RESPONSE TO EXPERT PANEL MINUTE 16 MT WELCOME, PUKERUA BAY

TO	Pukerua Property Group LP	DATE	31 August 2026
PROJECT NAME	Mt Welcome, Pukerua Bay	ENVELOPE REF	1753-02
ATTENTION	William Dorset	FROM	Kyle Dirse
EMAIL ADDRESS	william.dorset@classicdevelopments.co.nz

This memorandum responds to the requests for information in paragraph 9 of Minute 16 of the Expert Panel (FTAA-2603-1181, 28 August 2026) that relate to Envelope Engineering's assessments.

(b)(i) Status and design water levels of the Muri reservoir

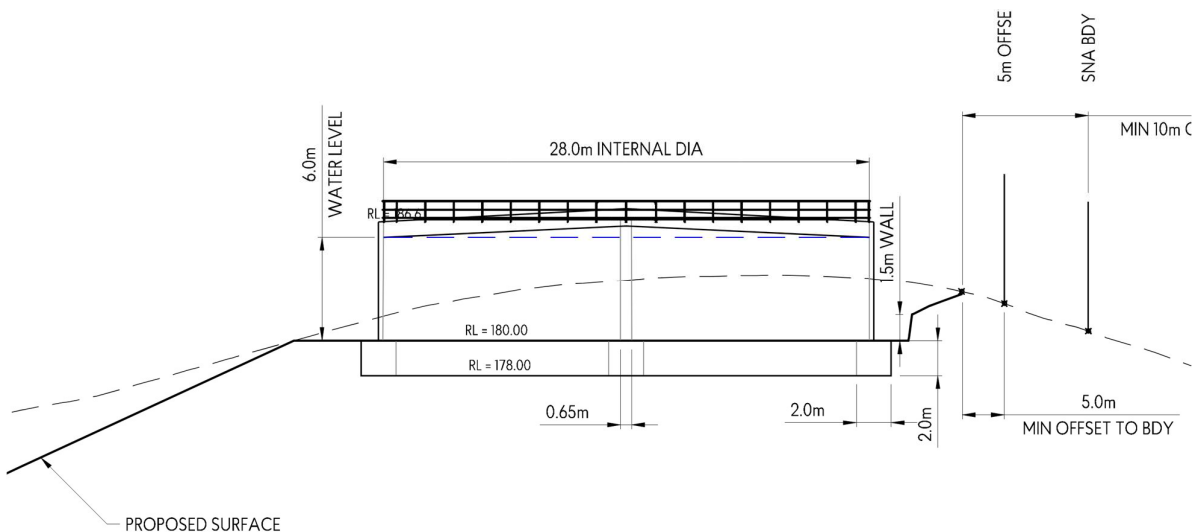
The Panel requests that the applicant outline the status of the Muri reservoir site in terms of current design plans and/or planning approvals and indicate the degree of certainty of the likely design top and bottom water levels of the reservoir. We note that PCC LIDAR information indicates the reservoir floor level is likely to be at approximately RL181m, but the reservoir site is on a reasonably restrictive 'dome-shaped' hill and any requirements for visual screening of the reservoir may result in a lower level of the reservoir so that the platform for the reservoir can contain the reservoir, access around the reservoir for maintenance and bunding or planting for visual screening. We request that the applicant comment on these matters so that the Panel can better understand the likely available water pressure at the Mt Welcome development.

The reservoir has been consented, and early contractor engagement has been undertaken. Detailed design has not yet progressed, as the reservoir is not required for the initial development stages. There is general agreement between the relevant landowners on the design approach, programme and allocation of costs.

The reservoir location, elevation, access and visual screening were addressed through the approved consent. The pressure zone and servicing limits were also assessed to confirm that the reservoir can service the intended lots without pressure gaps or future issues for homeowners.

Section 10 of the Infrastructure Report (Appendix 9, to the Application) adopts a top water level of RL186 m and a bottom water level of RL180 m for the upper-zone reservoir, which are the same as the consented reservoir levels. These levels are therefore considered reasonably certain. The figure below shows the proposed reservoir location and levels.

TITLE:
RESERVOIR SUPPLY
LOTS OVER RL 155

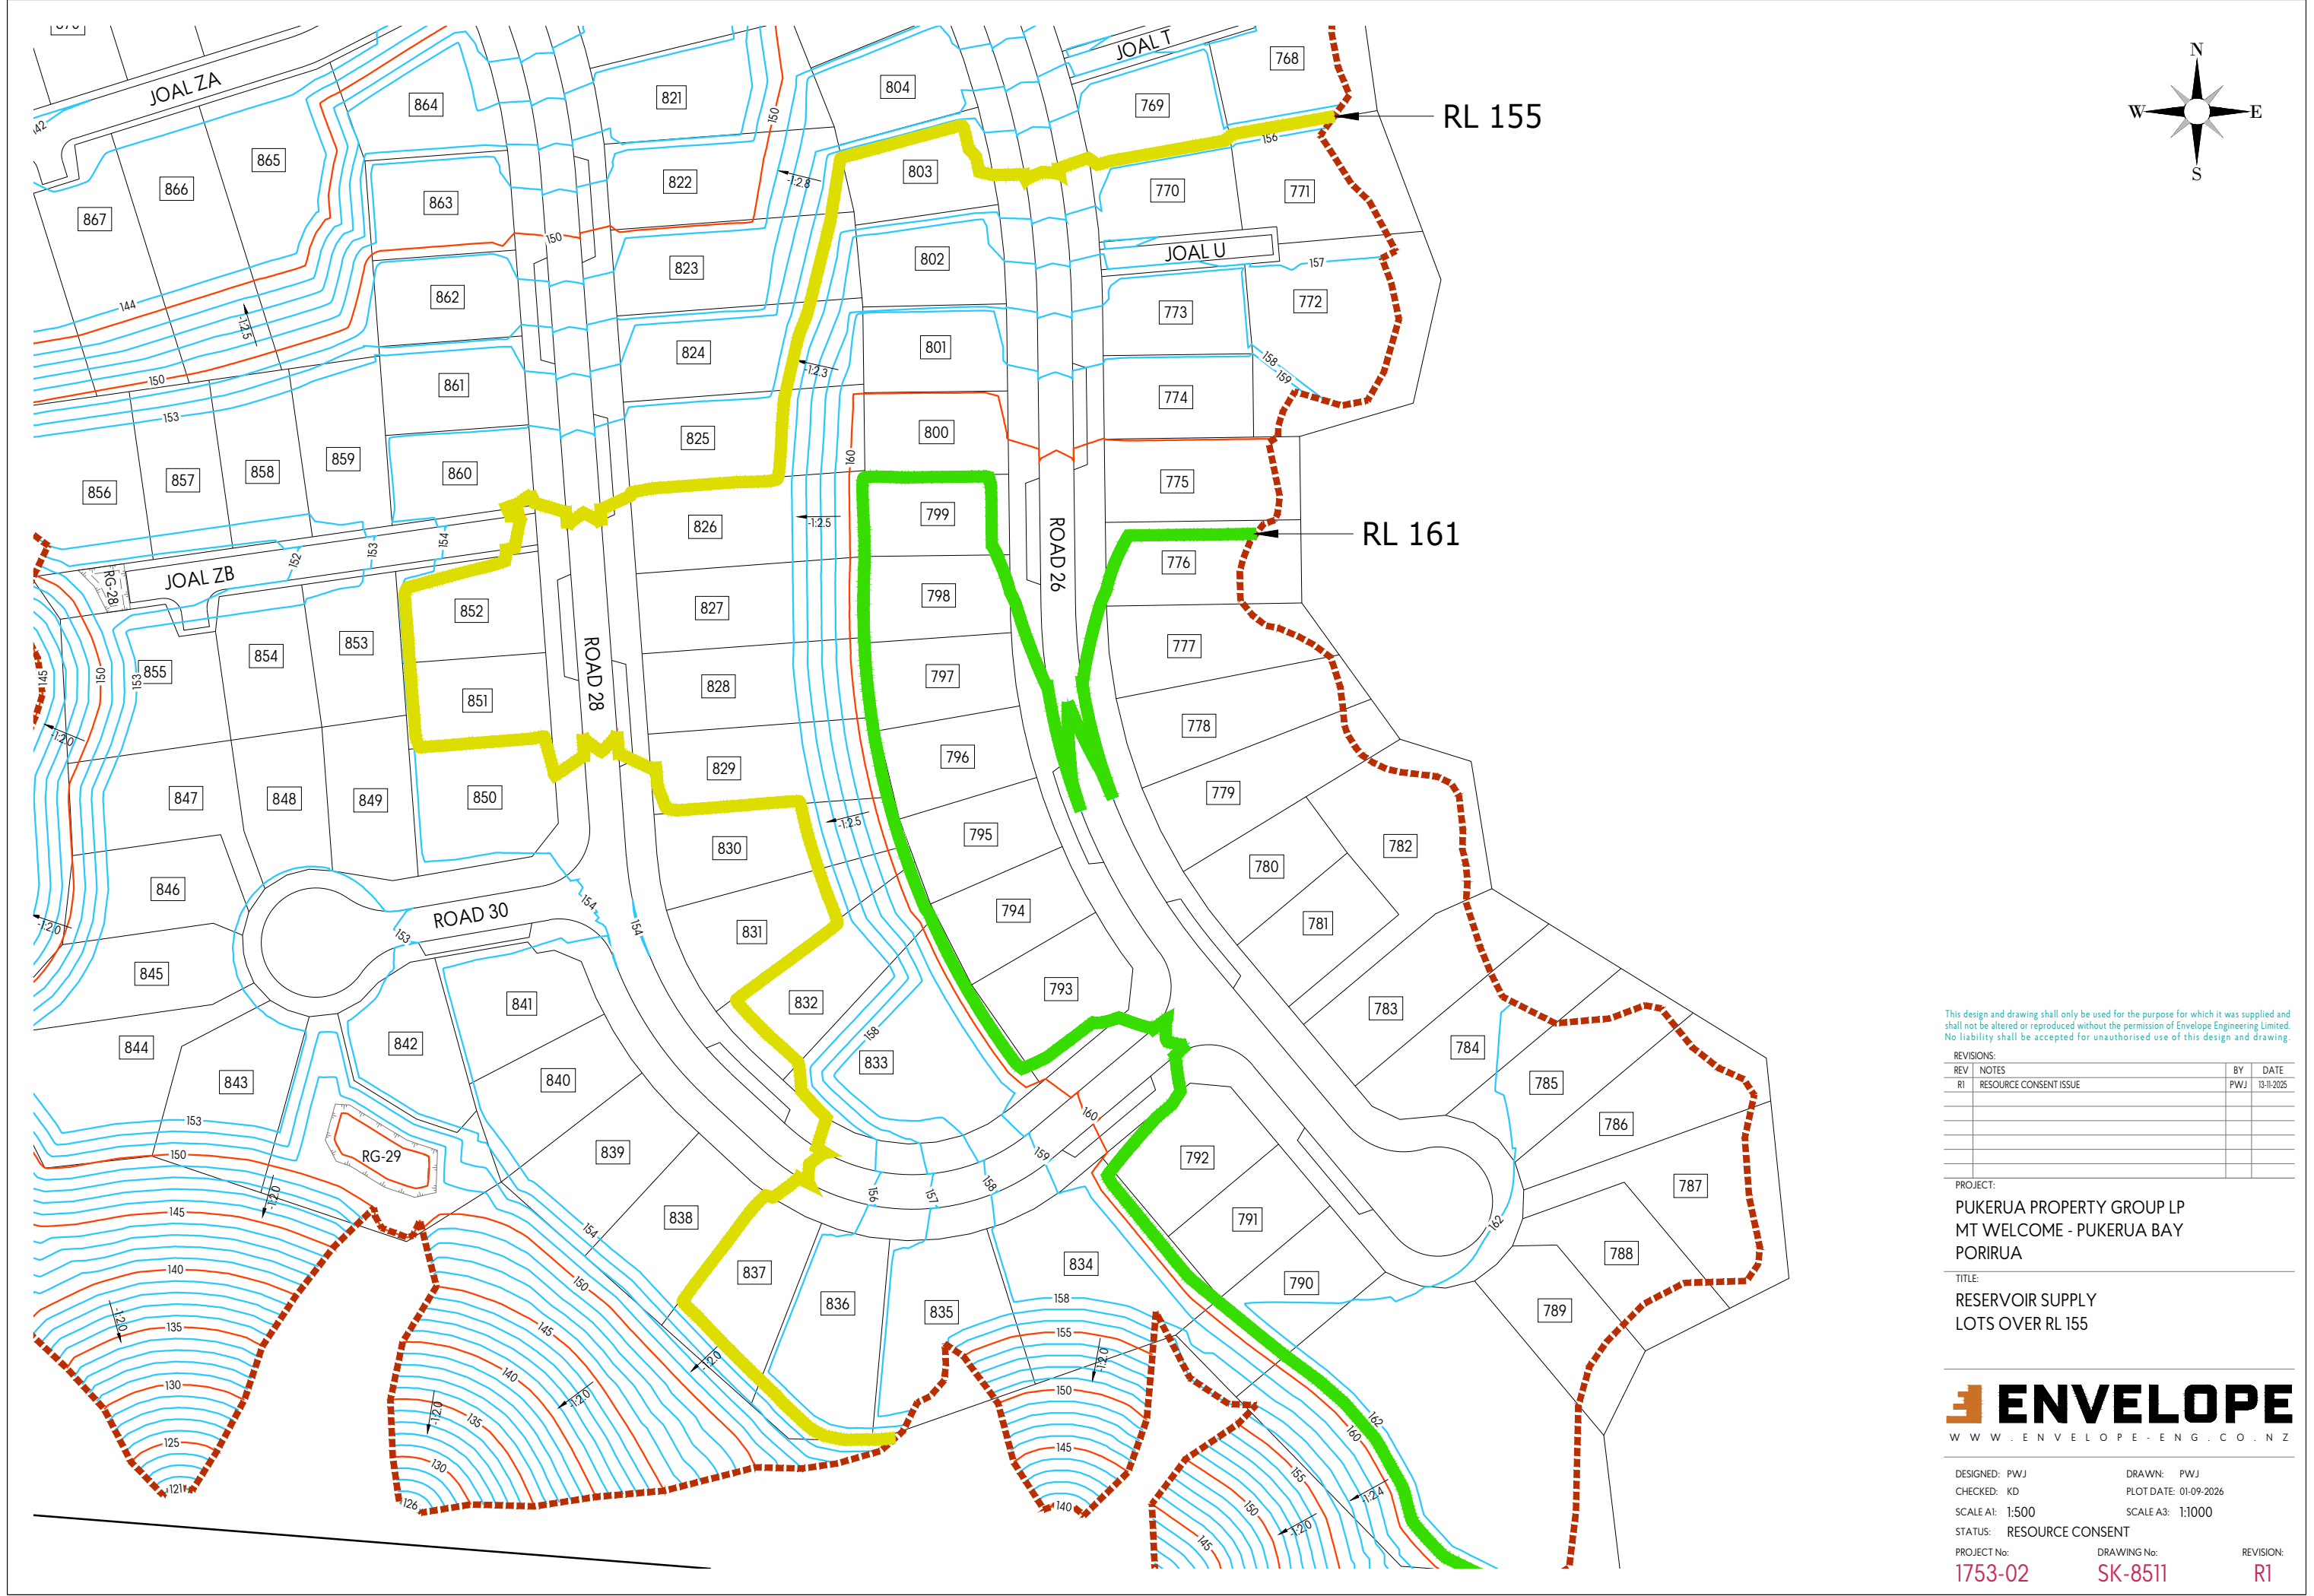
(b)(iii) Lots not meeting the minimum pressure, and the shortfall

We note that Drawing 2130 R1 shows lots 785 – 790 as being formed at a proposed level of RL162. Drawings 2129 & 2130 shows lots 770 – 803 and lots 833 – 836 as being above RL155.

We request that the applicant confirm which lots are likely to not meet the minimum pressure requirements set by the RSWS and advise the likely shortfall in available pressure at peak domestic demand for those lots. In its response to comments, the applicant suggested that consent orders were not required to address this situation. If, having considered the above matters, the applicant maintains that position, the Panel requests that the applicant advise what level of shortfall would justify consent orders.

The reservoir has a BWL of RL180 and a top water level (TWL) of RL186. The highest lots are formed at approximately RL162 and would therefore receive approximately 18m pressure at BWL and approximately 24m when the reservoir is near TWL. All lots would receive at least approximately 18m pressure at BWL.

Plan SK-8511 R1 identifies the lots that would not achieve 25m pressure when the reservoir is at BWL. With the reservoir at RL180, the maximum lot level that can achieve 25m of static pressure is approximately RL155.

Assessed against Tiaki Wai RSWS Table 6-1 with the reservoir at BWL:

Zone	Lots	Total
RL 155-161	770, 771, 772, 773, 774, 775, 800, 801, 802, 803, 826, 827, 828, 829, 830, 831, 832, 833, 834, 835, 836, 837, 851, 852	24
RL 161 and 162	776, 777, 778, 779, 780, 781, 782, 783, 784, 785, 786, 787, 788, 789, 790, 791, 792, 793, 794, 795, 796, 797, 798, 799	24

Lots 785–790 are formed at approximately RL162 and represent the highest affected lots. These lots would receive approximately 18m pressure at BWL and approximately 24m under normal operation when the reservoir is near TWL.

We maintain that reduced-pressure consent notices are not required. Under normal operating conditions, the minimum pressure at the highest lots would be approximately 24m, representing only a 1m departure from the 25m requirement. While pressure

may reduce to approximately 18m when the reservoir is empty, this remains well above the 10m minimum contemplated by the RSWs. The reduced pressure would not compromise the firefighting supply.

If the Panel does not accept the proposed 24m pressure under normal operating conditions, a condition could be proposed requiring private booster pumps for the specifically affected lots, with that requirement secured by consent notice. The final booster pump arrangement would be confirmed through detailed design and the building consent process.

The Applicant agrees that the affected lots and the proposed reduced minimum pressure should be confirmed with Tiaki Wai through the detailed design and engineering approval process. Plan SK-8511 R1 identifies the lots that may receive less than 25 m pressure when the reservoir is at BWL.
